SI B51 04 15  
Body Equipment

**Rear Spoiler Makes Rattling Noise Against Rear Window**

I01(i3, i3 REx)

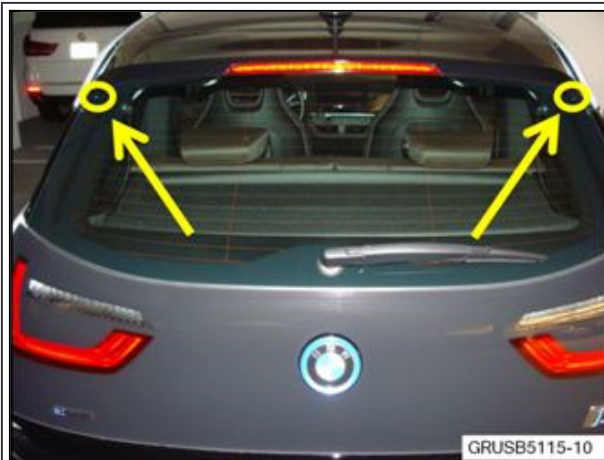
The left and right corners of the rear spoiler rattle against the rear glass.

1. Locate the rear hatch spoiler. Look at the clearance gap between the spoiler and glass in these two areas. If the gap is less than 3.2 mm, the buffers stops in the spoiler must be replaced with a new design flat head buffer.

2. Shown is a close-up of the right side buffer. Check if both left and right side buffers are providing enough clearance between the extreme corners of the rear spoiler and the rear glass.

If the gap between the glass and spoiler (at the bump stop) is less than 3.2 mm, both rear spoiler bump stops must be replaced.

Part Number	Description	Quantity
51 62 7 419 281	Flat head rubber buffer	2
